### ADDENDUM NO. 1 1

### ARDENWOOD PARK AND RIDE LOT Project No. 403.0 (NTC A08-007)

June 24, 2008

This addendum is being issued with respect to the Ardenwood Park and Ride Lot Project, Project No. 403.0, Contract No. A08-007.

### a. DEMOLITION PLAN, SHEET 4 OF 43:

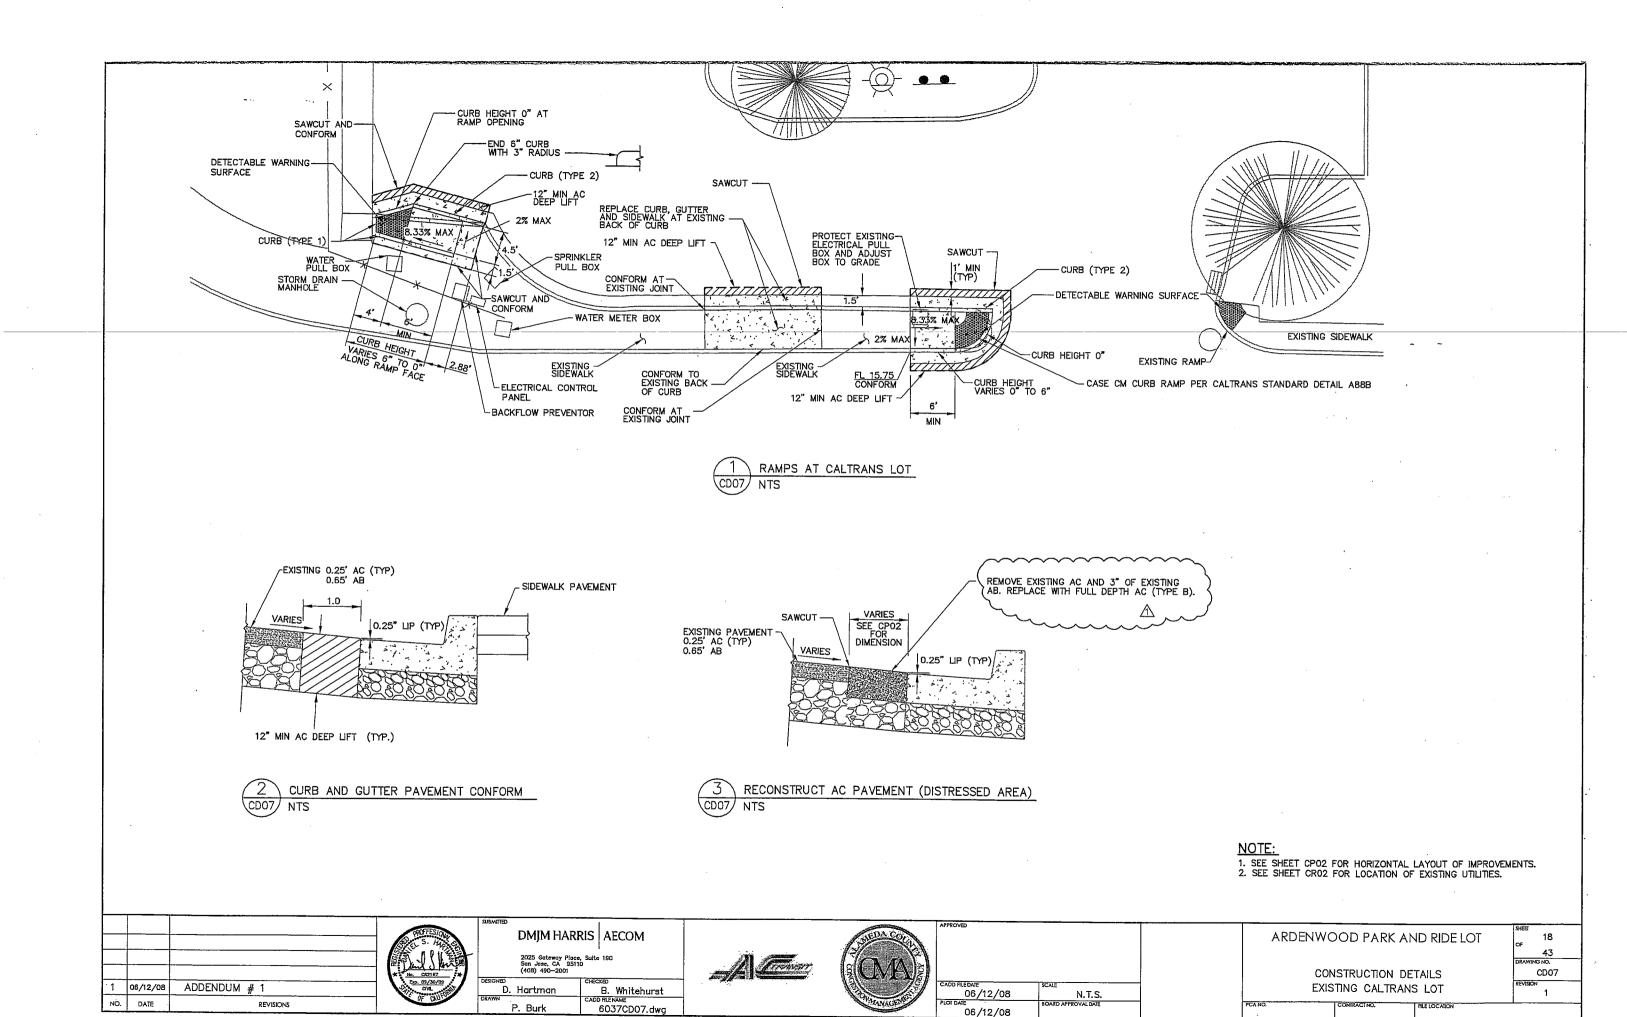
- Notes 6 is added as "6) FOLLOWING REMOVAL OF LOCKERS, DELIVER TO CALTRANS PETALUMA MAINTENANCE STATION, 611 PAYRAN STREET, PETALUMA, CA 94952. CONTACT JOHN O'NIELL WITH CALTRANS AT (707) 753-1100, 48 HOURS TO DELIVERY."
- A note "SEE NOTE 6" is added to item 13.
- b. **CONSTRUCTION DETAILS, EXISTING CALTRANS LOT, SHEET 18 OF 43** The note "REPLACE WITH AC (TYPE B) AND AB AT SAME THICHNESS." is changed to "REPLACE WITH FULL DEPTH AC (TYPE B)" in detail 3.

### c. SIGNING AND STRIPING PLAN, SHEET 21 OF 43:

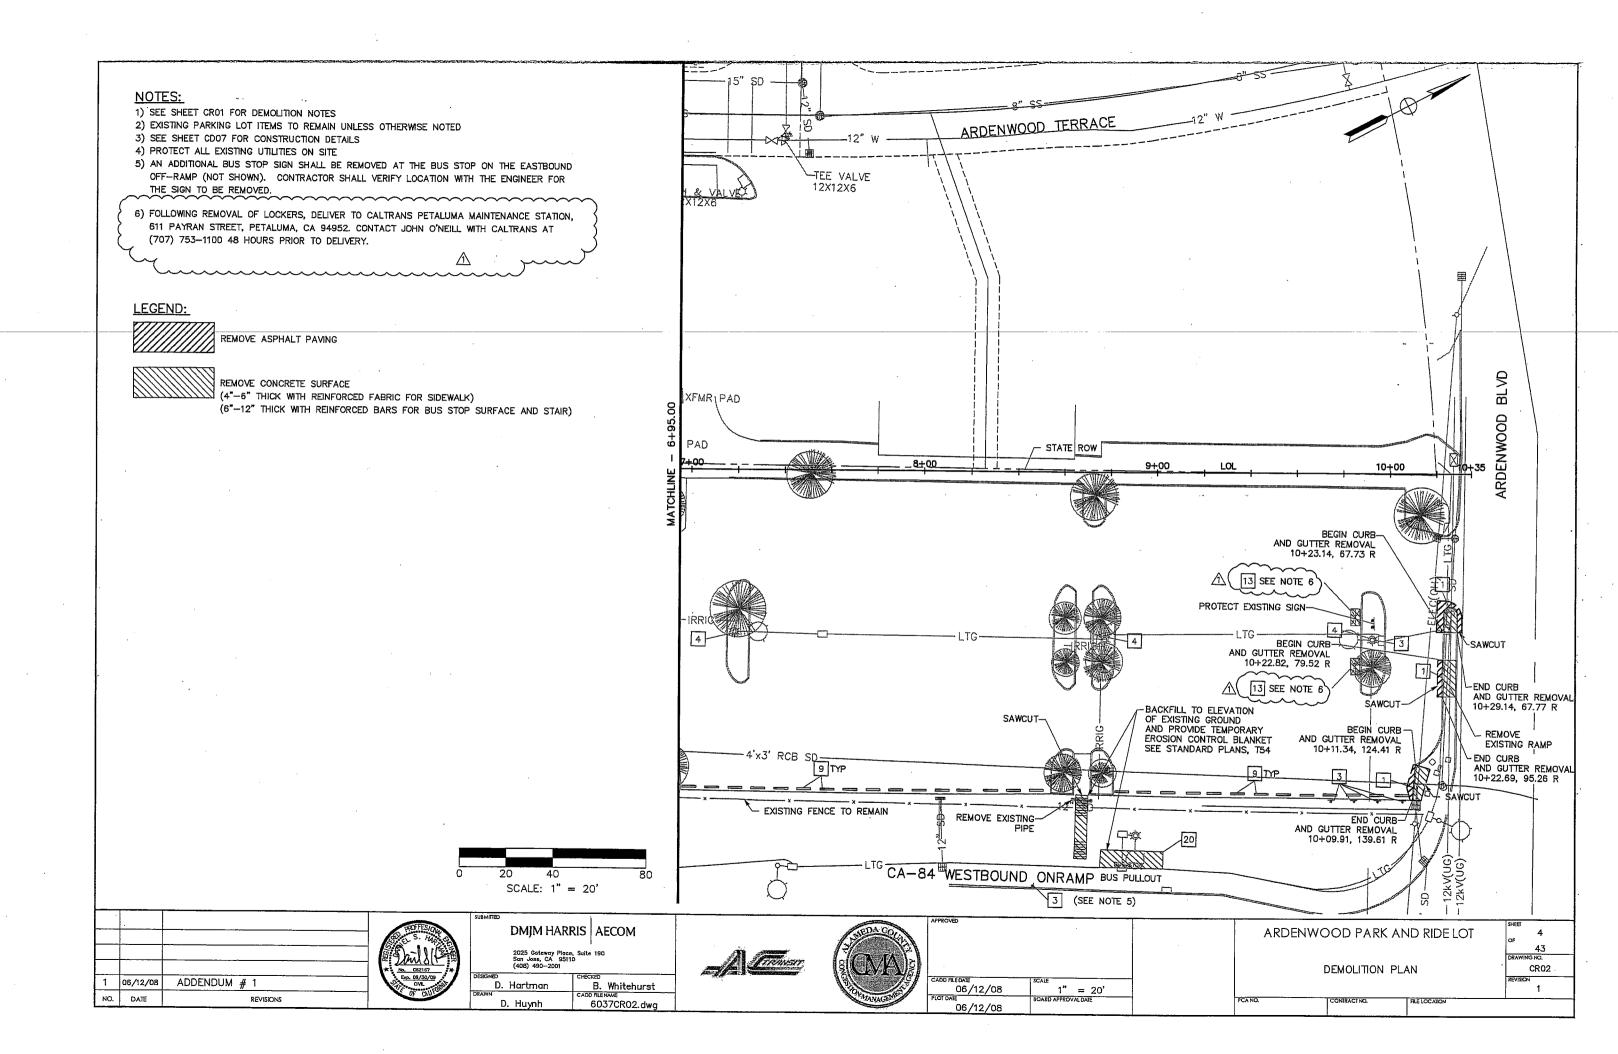
- The note 4 is revised to "PEDESTRAIN (ES-7P) TYPE 1 BARRICADE WITH R5-10A SHALL BE PROVIDED AT THE EASTBOUND ON-RAMP LOCATION. ENGINEER TO DESINATE LOCATION OF BARRICADES IN FILED."

- A note 5 is added as "PEDESTRAIN (ES-7P) TYPE 1 BARRICADE WITH R5-10C SHALL BE PROVIDED AT THE EASTBOUND OFF-RAMP LOCATION. ENGINEER TO DESIGNATE LOCATION OF BARRICADE IN FIELD."

- The Westbound On-Ramp Stripping is changed to conform to Caltrans Requirements. The diagonal stripes is reversed its direction. The stripes shall be painted in North-South direction.

- The note of the pedestrian (ES-7P) barricade at the lower right hand corner of the plan is changed to "PEDESTRIAN (ES-7P) TYPE 1 BARRICADE WITH R5-10C. SEE NOTES 4 AND 5."

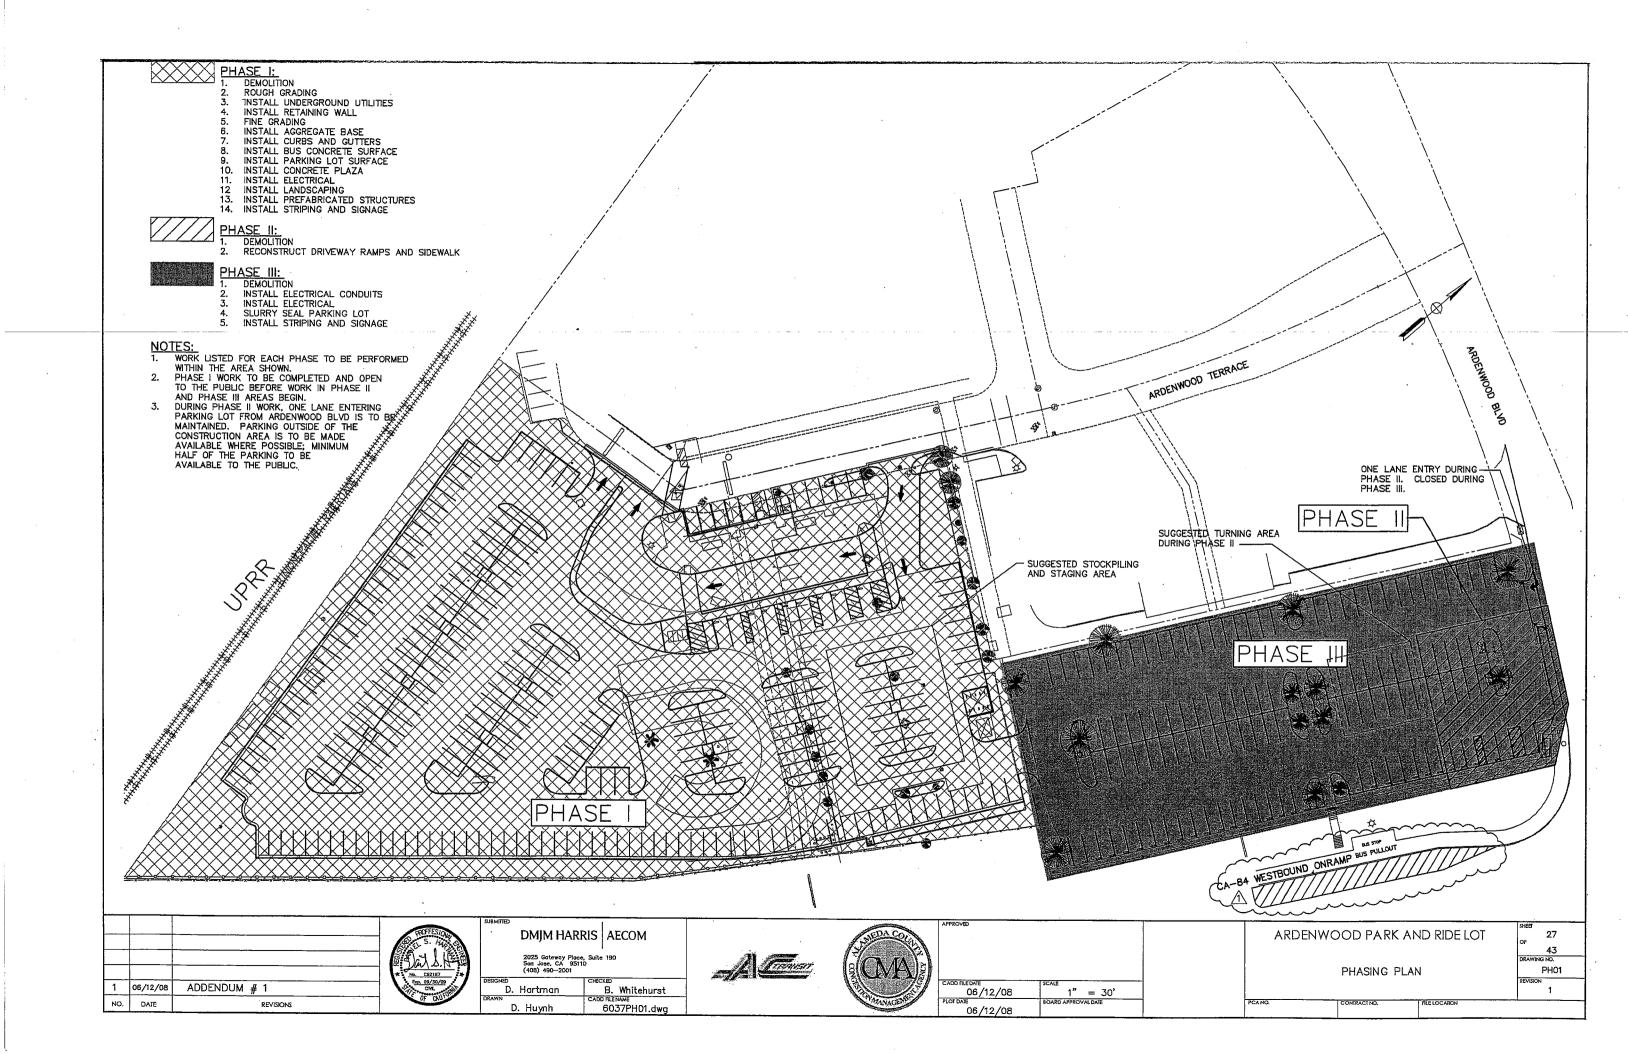
- d. **PHASING PLAN, SHEET 27 OF 43 -** The Westbound On-Ramp Striping is changed to conform to Caltrans requirements. The diagonal stripes is reversed its direction. The stripes shall be painted in North-South direction.

### e. ELECTRICAL DETAILS, SHEET 42 OF 43:

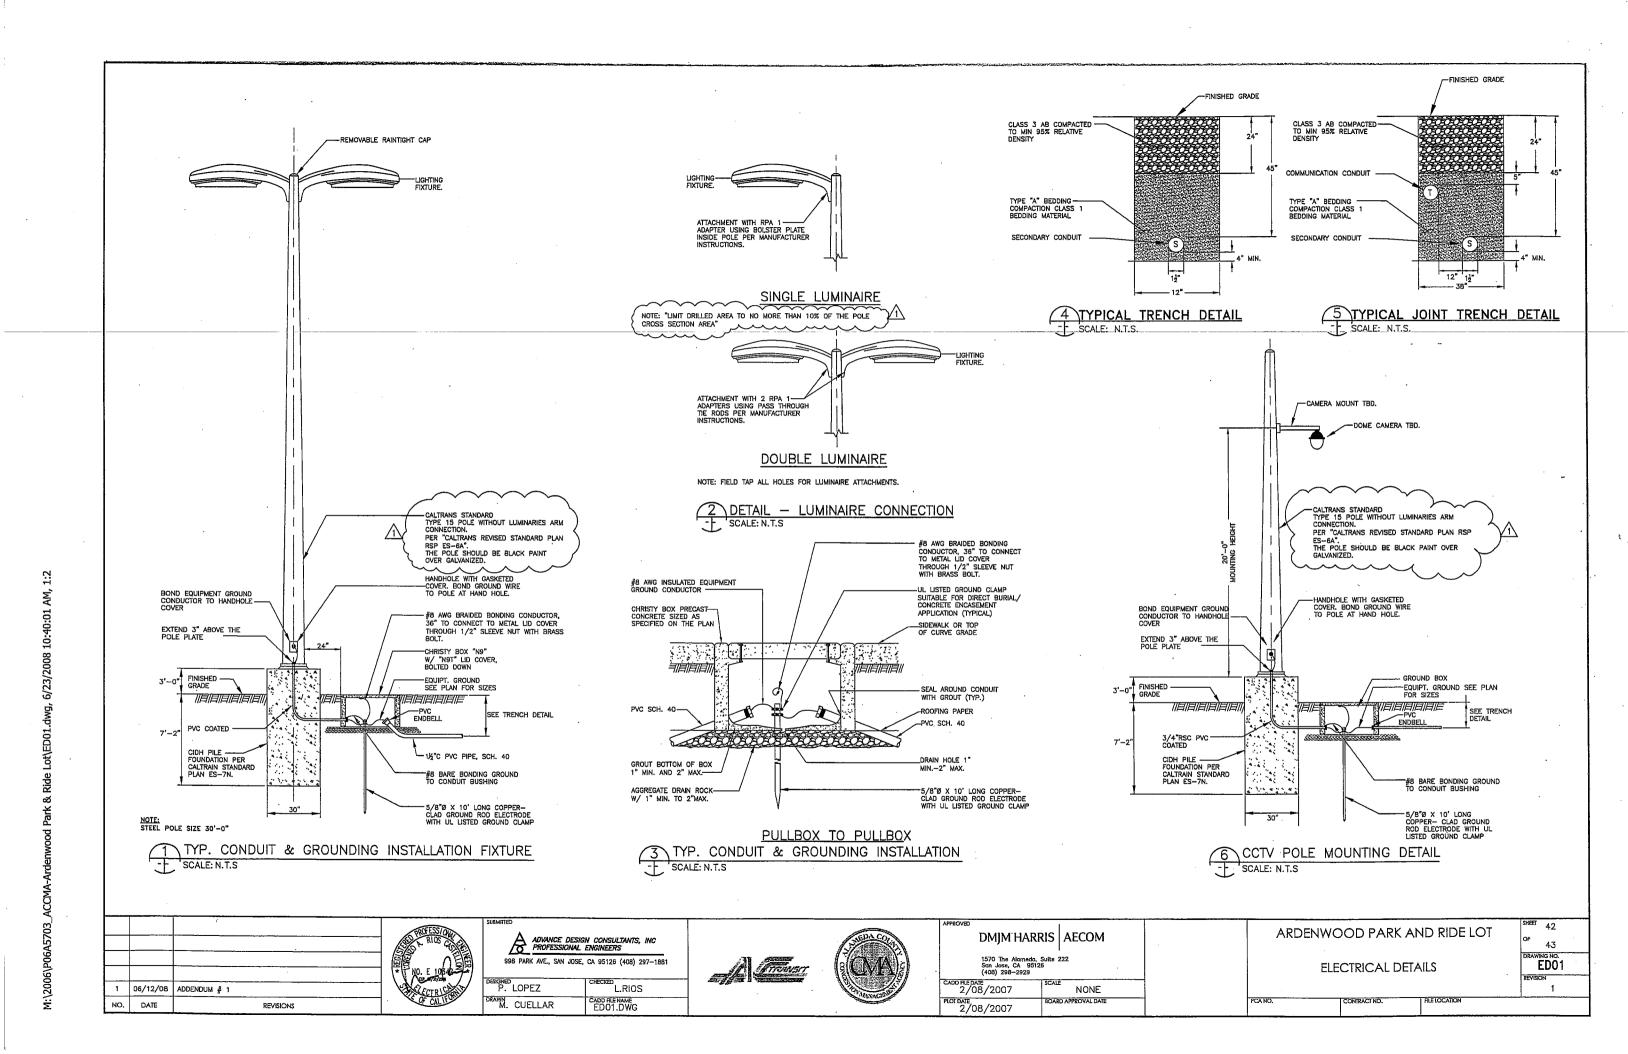
- The note reference to "Caltrans Standard Plan ES-6A" changed to "Caltrans Revised Standard Plan RSP ES-6A" on Detail 1 and 6.
- A note added to Detail 2 limiting drilled area to 10% of the pole cross section area.
